IMPORTANT: SGM364 units with a serial number of MF0000000 or later are equipped with a 14,000 BTU (D size) burner and other minor changes. Please take care when ordering parts and check the serial number so that you do not order incorrect parts or confuse newer units with older cooktops that do not have the 14,000 BTU burner.

SGM364 - Assembly Before Serial # MF0000000

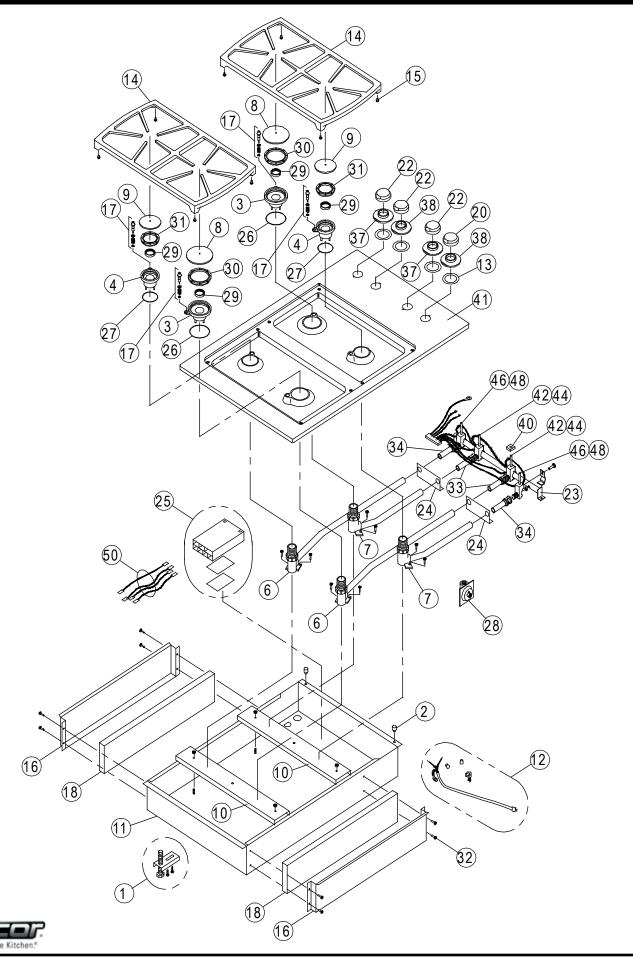
¹The grates have been redesigned. You may need to replace both grates to make sure they match.

²**IMPORTANT:** The ignitor assembly and burner rings were redesigned on later versions of the cooktop. The older designs are no longer available. The new ignitor design only works with the newer burner ring design, while the new burner ring design is compatible with all versions of the ignitor assembly. When replacing the ignitor assembly check to make sure the latest version of the burner ring is installed. If the burner ring has a hole on its side (see diagrams below), it must be replaced with correct size (B or C) of the newer version. Items 30 and 31 above list the part number for the newer versions of the burner ring.

SGM364 - Assembly After Serial # MF0000000

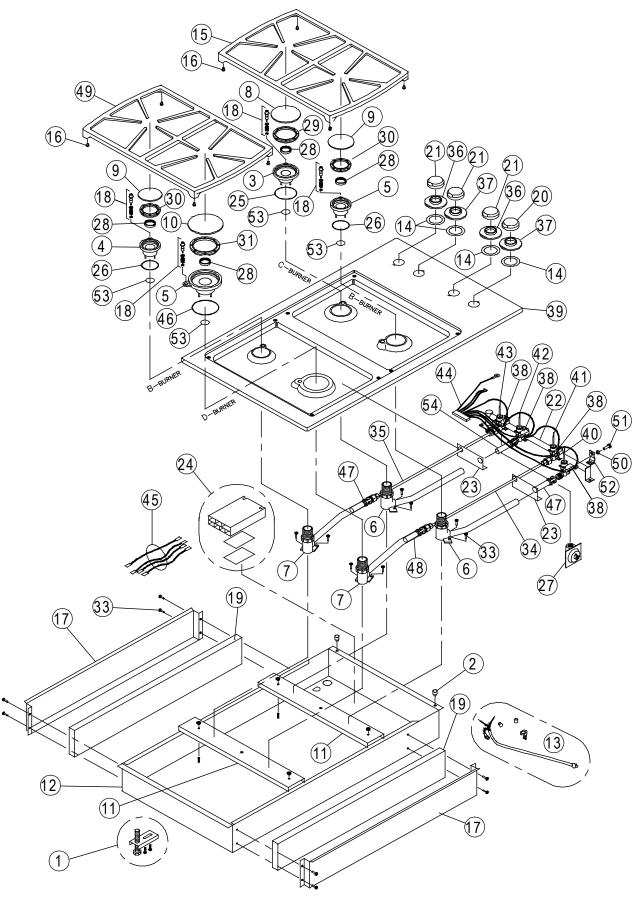
¹Effective with revision G of the cooktop, the grates were redesigned. On cooktops manufactured before revision G, all three grates may need to be replaced to make sure they match.

²**IMPORTANT:** The ignitor assembly and burner rings were redesigned on later versions of the cooktop. The older designs are no longer available. The new ignitor design only works with the newer burner ring design, while the new burner ring design is compatible with all versions of the ignitor assembly. When replacing the the ignitor assembly check to make sure the latest version of the burner ring is installed. If the burner ring has a hole on its side (see diagrams below), it must be replaced with correct size (B, C or D) of the newer version. Items 29, 30 and 31 above list the part numbers for the newer versions of the burner ring.

³For complete burner set of burner rings, order part number 72929. 72929 contains 2 B size rings, 1 C size ring and 1 D size ring.
